RE: Crestwood North Park, PR2102 – Request for information

RFI #1

HM DOOR LOUVER

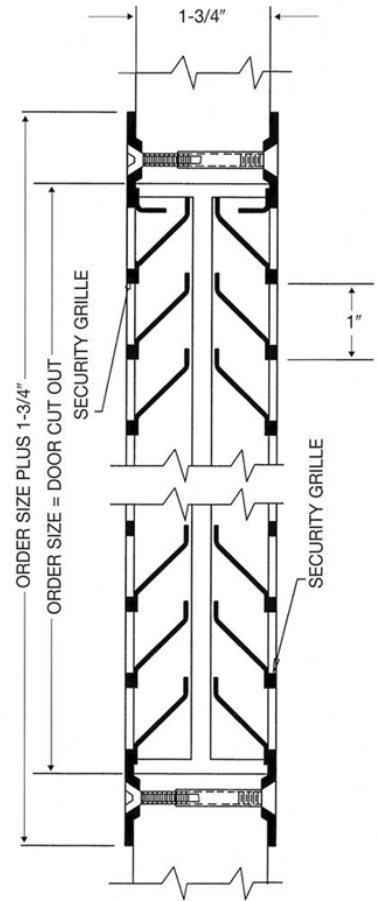
2. - Door schedule sheet A3.0 calls out to refer to Specifications section 08710 for hardware. Please post or email the hardware specs so we can price accordingly.
- Door type A calls for Aluminum louver in door. Advise aluminum louver manufacturer with valid hurricane component test that can be used in a Hollow Metal door. Otherwise, Windstorm louver component tested will be STEEL per HM door Product approval (not aluminum).

Door louver to be HM not aluminum.

WALL LOUVER

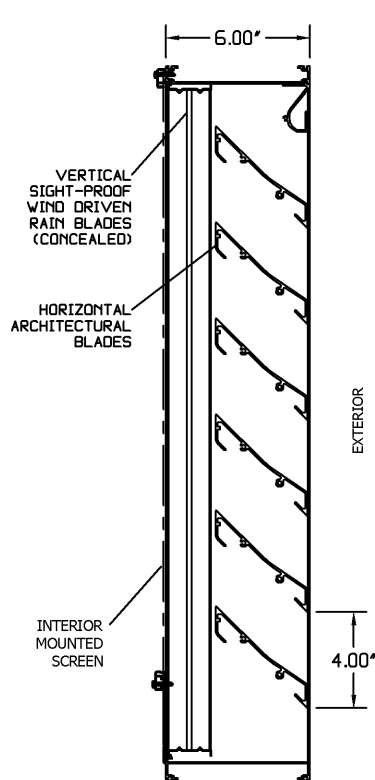
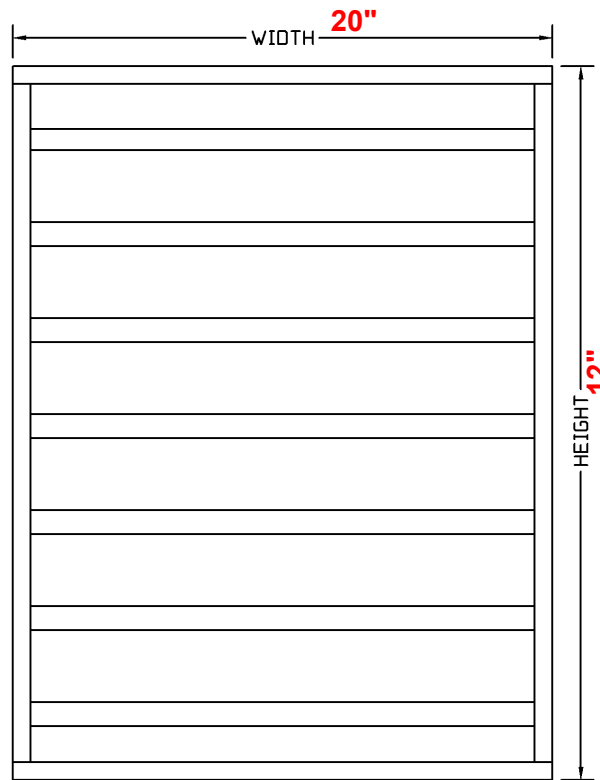
- 1) The wall louvers on sheet A1.0 at the Restroom bldg.. say to refer to Mech. Drawings. Could this be provided?
See the attached louver shop drawing, it meets the contract specifications
- 2) Could you provide specifications for the approved metal roof system at the restroom building.
See section 074130 Metal Roof Panels in the specifications.
-
- 3) In the addendum #2 there are notes about the bid schedule. ***** under item 750.013.
Could you clarify this is correct? Yes, it is correct
- 4) Under addendum #2 there is a note on the shop drawings of the pavilions about T & G Decking that the owner will purchase and the contractor will install. Is this correct? Yes
